Proposed Access Alterations, Dixons Brooklands Academy, Wythenshawe, Manchester

Transport Statement

DIXONS BROOKLANDS ACADEMY, WYTHENSHAW PROPOSED INTERNAL ARRANGEMENT AMENDMENTS

STAGE 1 ROAD SAFETY AUDIT

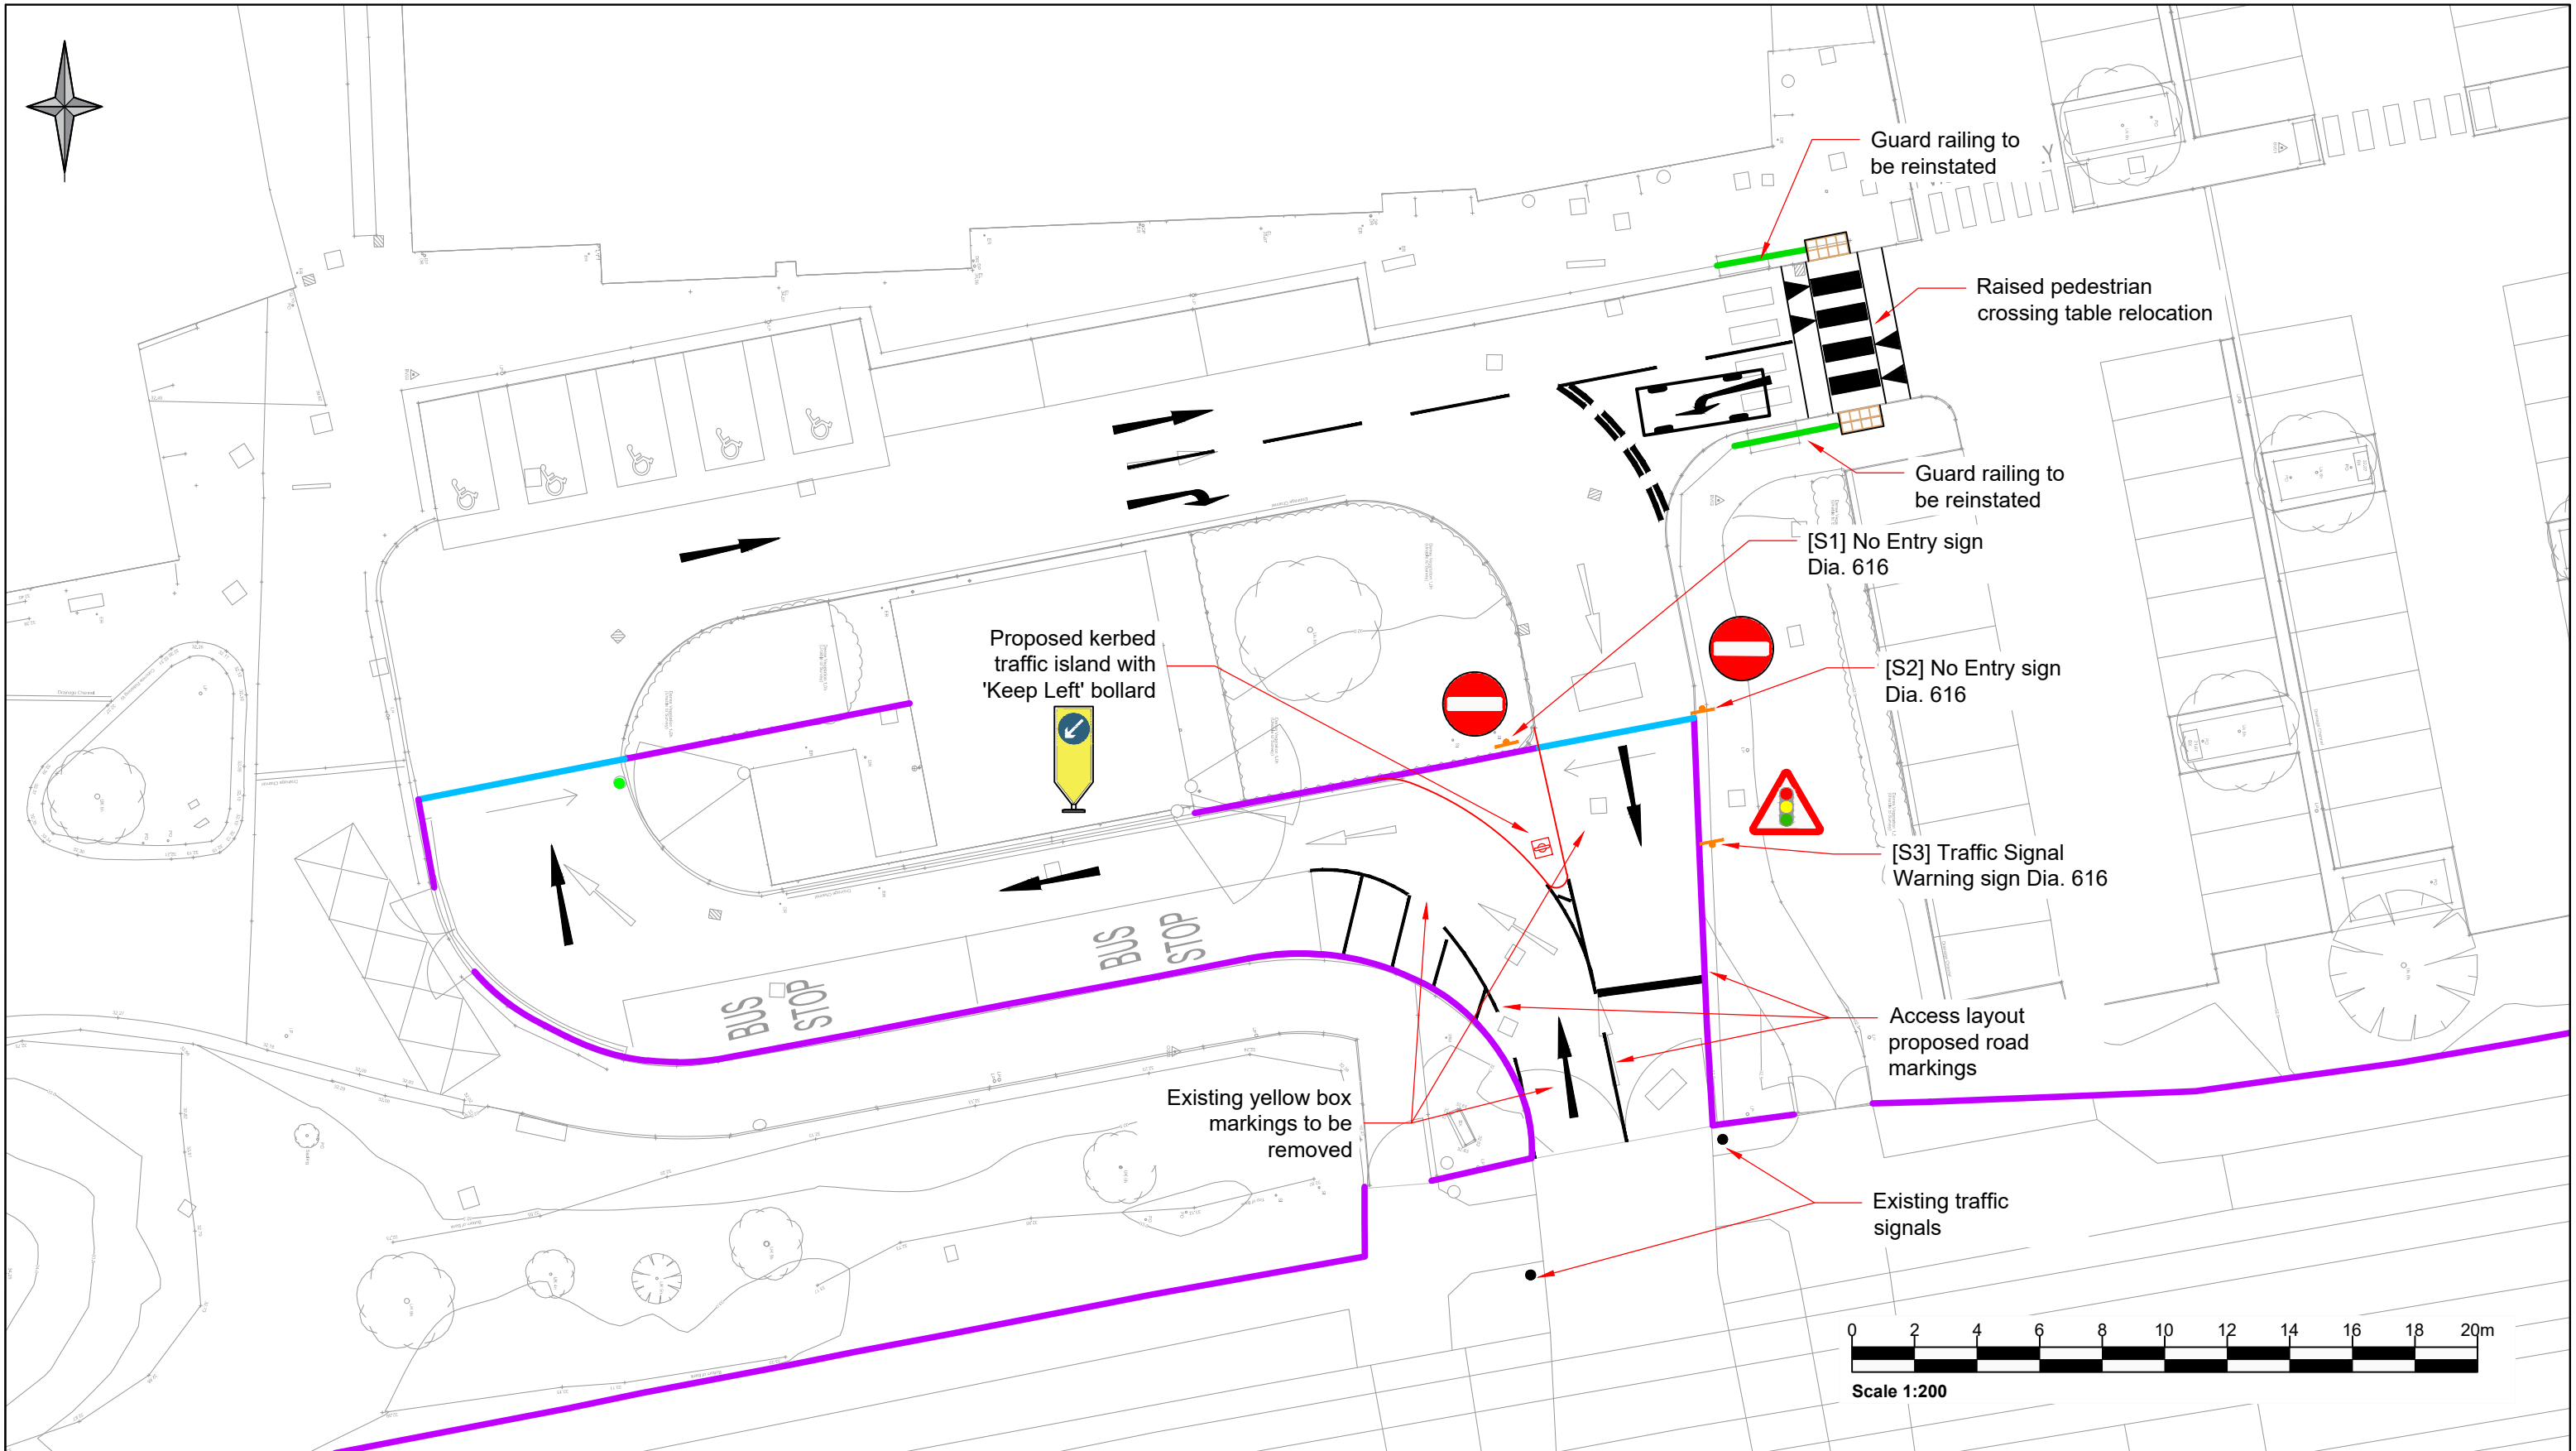
It was observed during the site visit that the existing informal zebra type pedestrian crossing within the school car park, that is due to be relocated, is on a raised platform, however, the drawings provided for audit do not show if the relocated pedestrian crossing is to be installed on a raised platform. Omission of vertical deflection at the informal zebra type pedestrian crossing, may result in excessive vehicle speeds at the crossing which may increase the risk of pedestrian collisions with vehicles, or may increase the severity of injury should a collision occur.

The drawings provided for audit do not show a keep-left bollard on the nose of the proposed kerbed traffic island. Omission of a keep-left bollard may increase the risk of vehicles colliding with the pedestrian refuge island or vehicles traveling the incorrect side of the island increasing the risk of head-on type collisions.

The drawings provided for audit show a worded "Stop" road marking in front of the traffic signal stop line. A worded "Stop" road marking is only associated with a stop sign controlled major/minor priority junction. The provision of the "Stop" road marking may confuse drivers as to the type of junction control which may increase the risk of drivers failing to comply with a red traffic signal resulting in vehicular, vehicle/pedestrian, vehicle/cyclist or vehicle/tram collisions.

Problem Identified Ref.	Problem Identified Description / Recommendation	Designers Response (Describe)
2.4.1	<p>Location: At the relocated informal zebra type pedestrian crossing within the school car park.</p> <p>Problem: Omission of vertical deflection at the informal zebra type pedestrian crossing, may result in excessive vehicle speeds at the crossing which may increase the risk of pedestrian collisions with vehicles.</p> <p>It was observed during the site visit that the existing informal zebra type crossing within the school car park, that is due to be relocated, is on a raised platform, however, the drawings provided for the audit do not show if the relocated pedestrian crossing is to be installed on a raised platform. Omission of vertical deflection at the informal zebra type crossing which may increase the risk of pedestrian collisions with vehicles or may increase the severity of injury should a collision occur.</p> <p>Recommendation: It is recommended that the relocated informal zebra type crossing is installed on a raised platform as per the existing layout.</p>	<p>Recommendation accepted – The relocated informal zebra-type crossing will be installed on a raised platform, consistent with the existing site conditions. The amended zebra crossing layout is shown in Drawing A25105-0100-001 Rev P02.</p>

Problem Identified Ref.	Problem Identified Description / Recommendation	Designers Response (Describe)
2.5.1	<p>Location: Proposed kerbed traffic island</p> <p>Summary: Omission of keep-left bollards on the nose of the island may increase the risk of vehicles colliding with the island or travelling on the incorrect side of the road. The drawing provided for audit do not show a keep-left bollard on the nose of the proposed kerbed traffic island. Omission of a keep-left bollard may increase the risk of vehicles colliding with the island or vehicles travelling on the incorrect side of the island increase the risk of head-on type collisions.</p> <p>Recommendation: It is recommended that a keep-left bollard is provided on the nose of the proposed kerbed traffic island.</p>	<p>Recommendation accepted – A “Keep Left” bollard will be installed on the nose of the proposed kerbed traffic island at the site entrance, to prevent vehicles from travelling on the incorrect side of the carriageway. The provision of the “Keep Left” bollard is illustrated in Drawing A25105-0100-001 Rev P02.</p>

Problem Identified Ref.	Problem Identified Description / Recommendation	Designers Response (Describe)
2.5.2	<p>Location: At the traffic signal stop line within the school grounds</p> <p>Problem: Provision of worded “STOP” road markings may confuse drivers as to the type of junction control which may increase the risk of drivers failing to comply with a red traffic signal resulting in vehicular, vehicle/pedestrian, vehicle/cyclist or vehicle tram collisions.</p> <p>The drawings provided for audit show a worded “STOP” road marking in front of the traffic signal stop line. A worded “STOP” road marking is only associated with a stop sign controlled major/minor priority junction. The provision of the “STOP” road marking may confuse drivers as to the type of junction control which may increase the risk of drivers failing to comply with the red traffic signal resulting in vehicular, vehicle/pedestrian, vehicle/cyclist or vehicle tram collisions.</p> <p>Recommendation: It is recommended that the proposed worded “STOP” road markings are omitted from the scheme design.</p>	<p>Recommendation accepted – The proposed “STOP” road markings have been omitted from the scheme to avoid confusing drivers regarding the type of junction control.</p>
